Initial Assessment of EPRI  
Technical Report  
“Investigation of Strategies for  
Mitigating Radiological Releases  
in Severe Accidents”

Japan Lessons Learned Steering Committee  
October 9, 2012

Figure B-43  
Mark I, FloodRHVc, drywell pressure

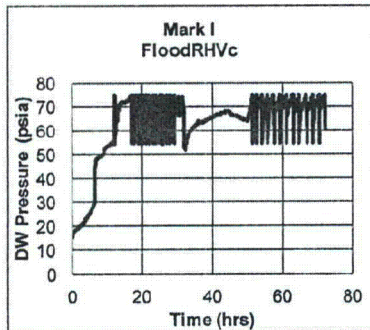
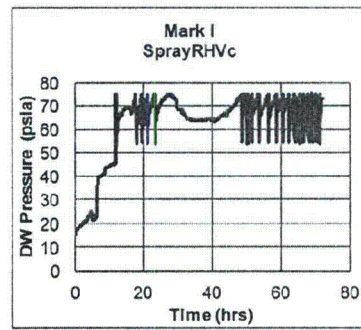
- Sept 27 Steering Committee statement
  - Manual venting twice in 1<sup>st</sup> 24 hours and once in next 24 hours
- Pressure plots from EPRI report 1026539
